MICE Integration Engineering

Jason Tarrant - STFC

- Contents
 - » Device Interfaces – General
 - » AFC
 - » Spectrometer Solenoids
 - » RFCC
 - » EMR / KL
 - » South Mezzanine (summary)

- Mezzanine & EMR

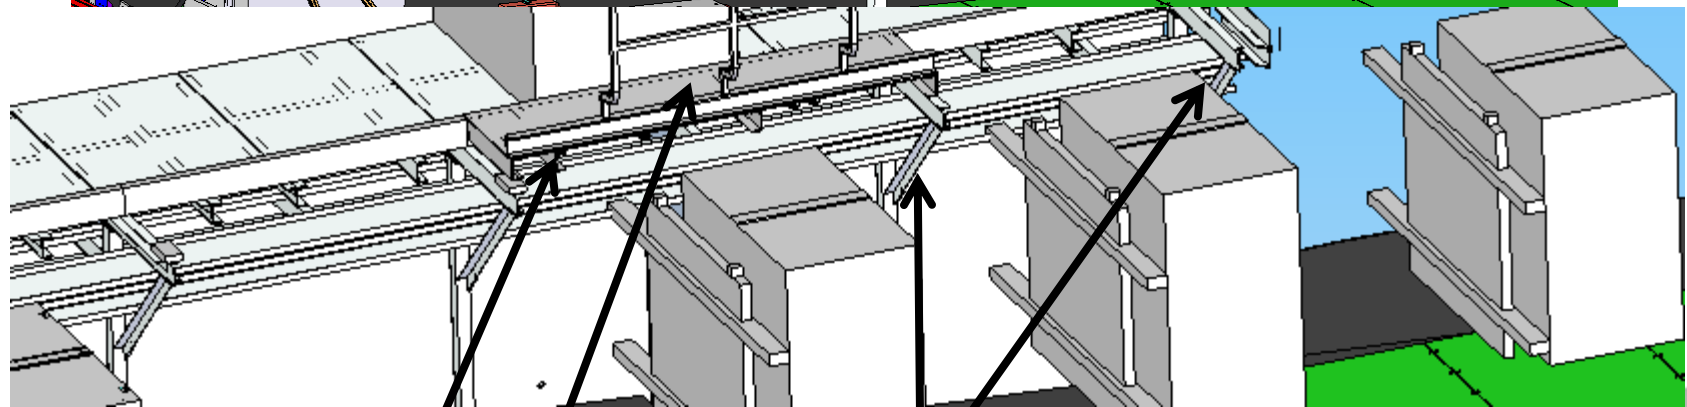
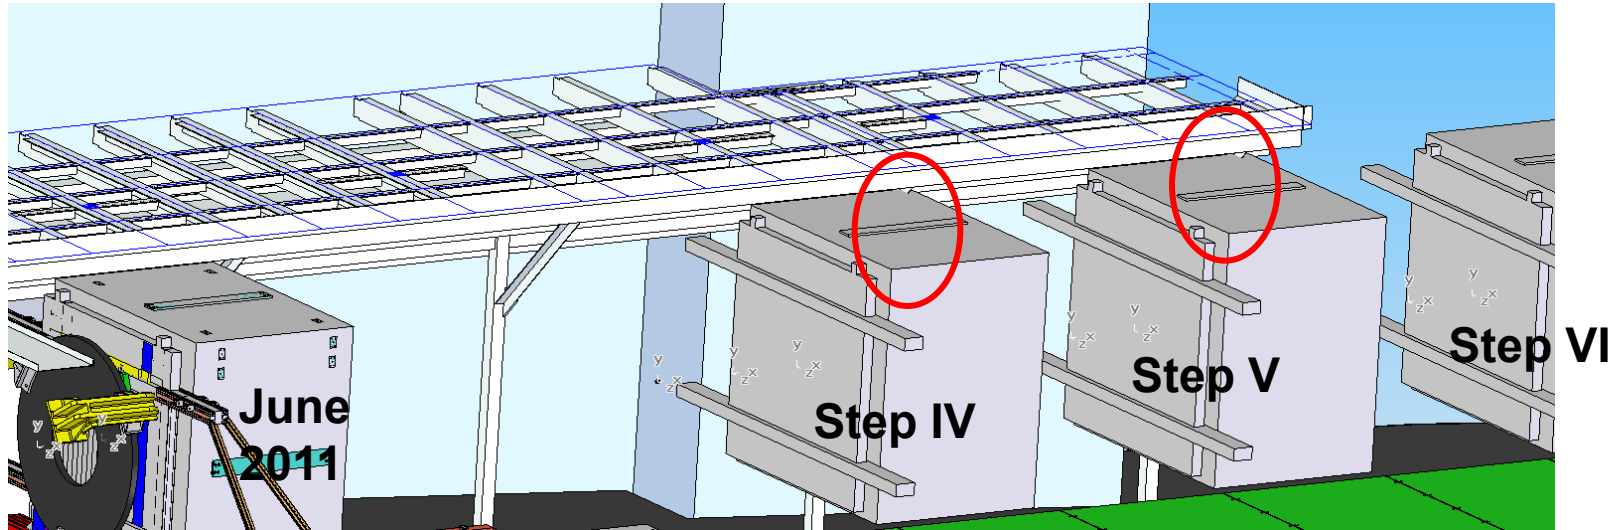
Potential clash
With support pillars

Beams cut back

Removable
floor section

Support
legs moved

Fig 1: Current South Mezzanine walkway

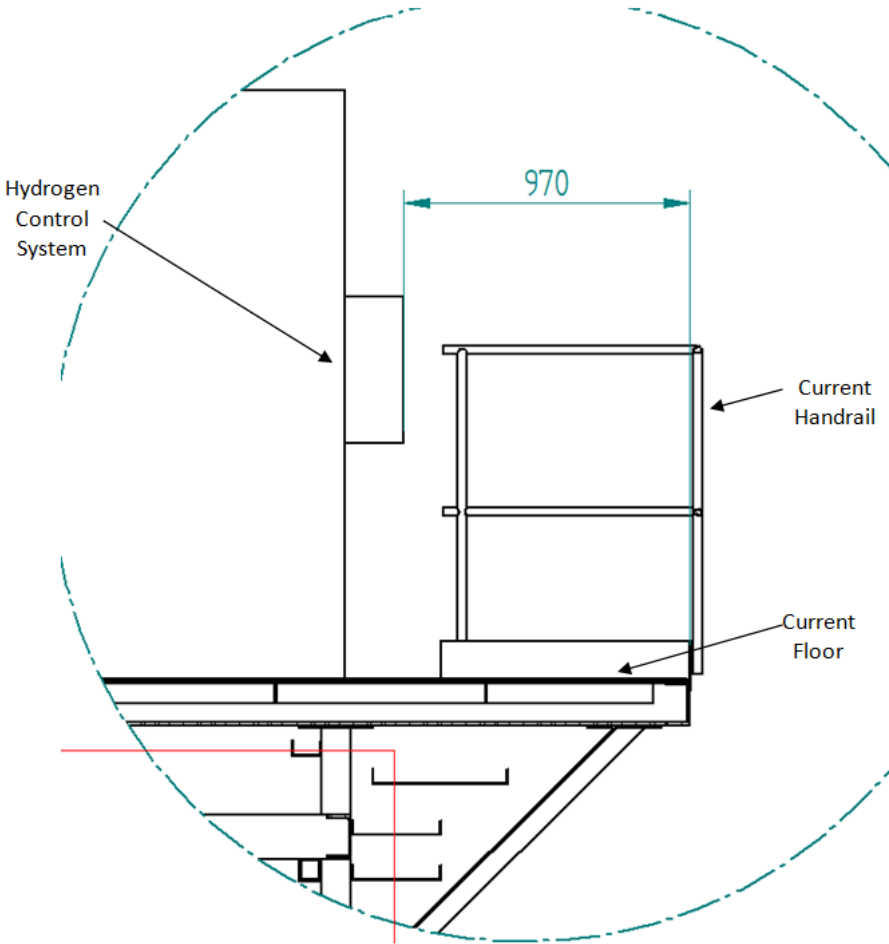
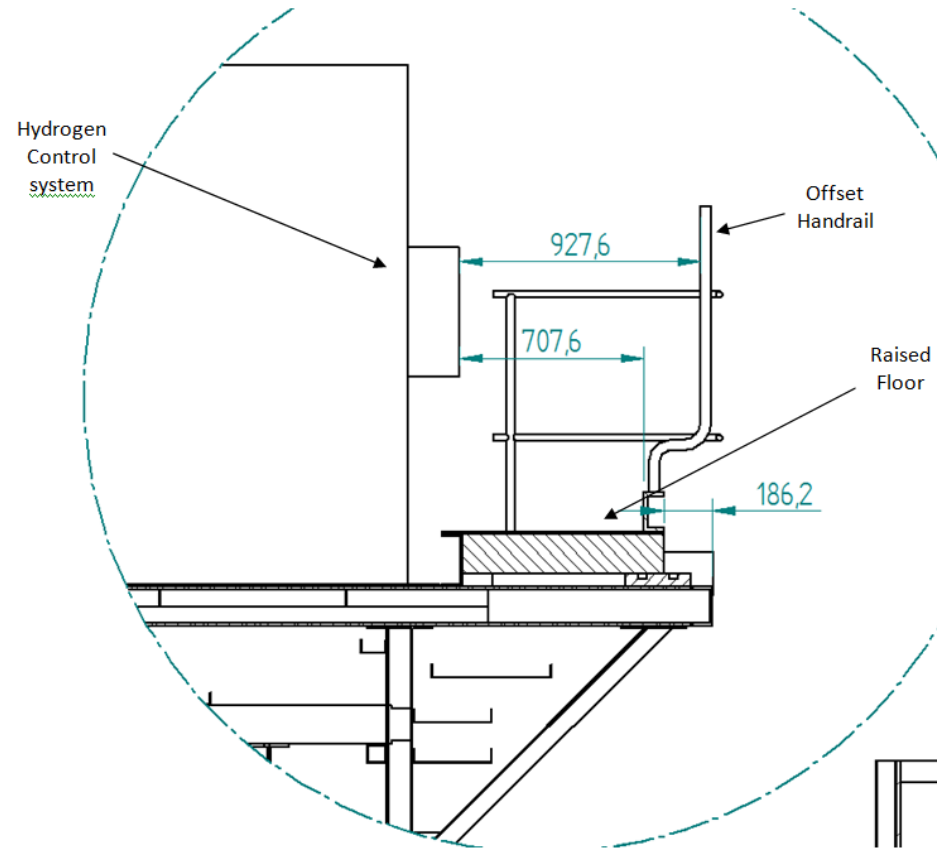
Fig 2: Proposed South Mezzanine walkway with raised floor and offset handrail

- South Mezzanine – Before change!
 - » Is the narrow walkway acceptable for safety?
 - » Can the H system frame & pipes be raised to give headroom?
 - » Can H system frame / pipes be temporarily removed to move platforms?
 - » Is the raised floor compatible with the hydrogen racks?
 - » What needs to be installed / moved along the mezzanine walkway? Is it compatible?
 - » Structurally OK?
